From: Steven Lopes
To: [Xinjian Chen](#)
Subject: FW: Manatee County - Rookery at Perico Seagrass Advance Mitigation
Date: Monday, September 16, 2013 12:03:24 PM
Attachments: [image001.png](#)
[Perico Responses 2.pdf](#)

**Reference: Response to Request for Additional Information
Manatee County - Rookery at Perico Seagrass Advance Mitigation
Application No. 678237
County: Manatee
Secs/Twps/Rges: 26/ 34 South/ 16 East, 27/ 34 South / 16 East**

Response to Request for Additional Information

Manatee County - Rookery at Perico Seagrass Advance Mitigation

Figure 25: Simulated Currents and Water Levels in the Culvert Interior, Final Calibration.

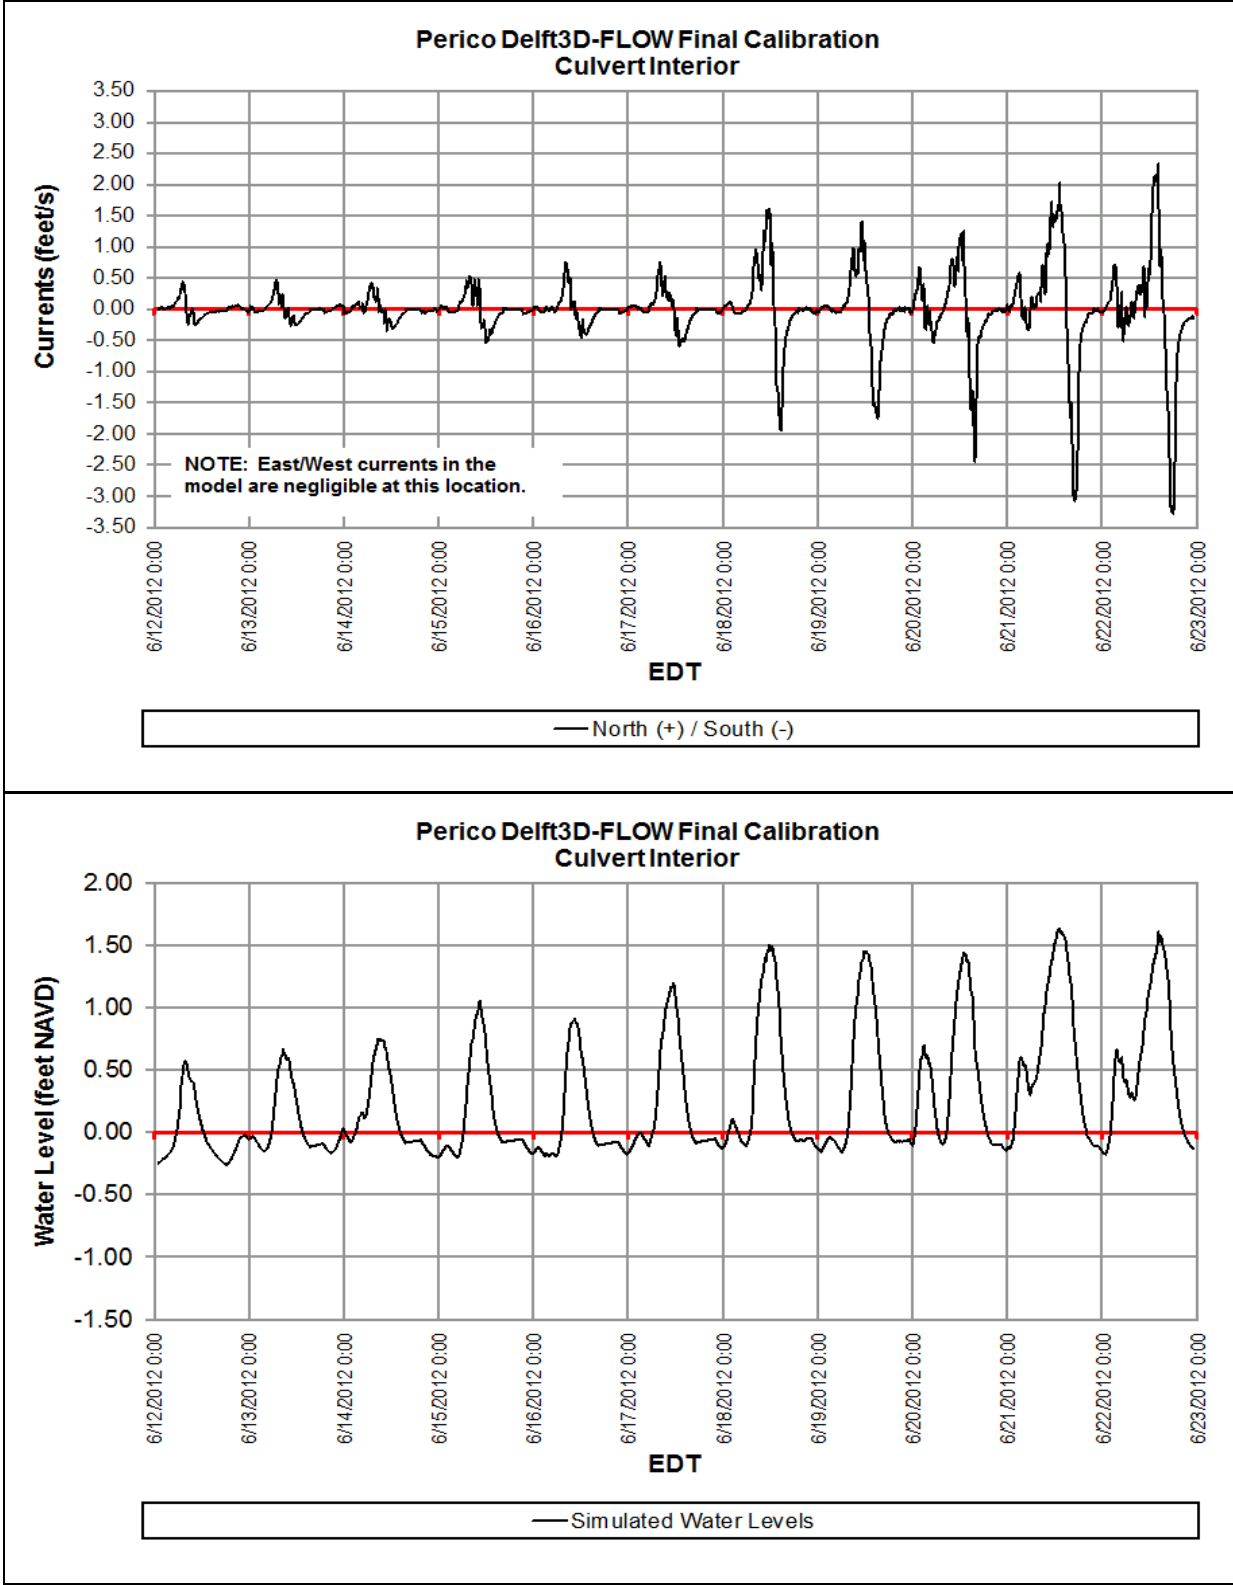
- d. Please explain how the upstream or upstream side of the culvert (or Manatee Ave bridge) is decided when flood and ebb currents through the culvert (bridge) were discussed. It appears that there is a contradiction when the terms 'flood' and 'ebb' currents were used in Figures 25, 38, and 39.

- e. Please revisit the units of current velocity in Figures 25 – 26 and 40 – 42 (eet/s should be feet/s, and feet/seconds should be feet/second).

As previously stated, the culvert is not relevant to the proposed design alternative. Within the culvert, the flood direction was assumed to be towards the north which is the existing inland direction. South is the ebb direction towards Spoonbill Bay.

Corrected. Revised pages 31, 32, 54, 55 and 56 attached.
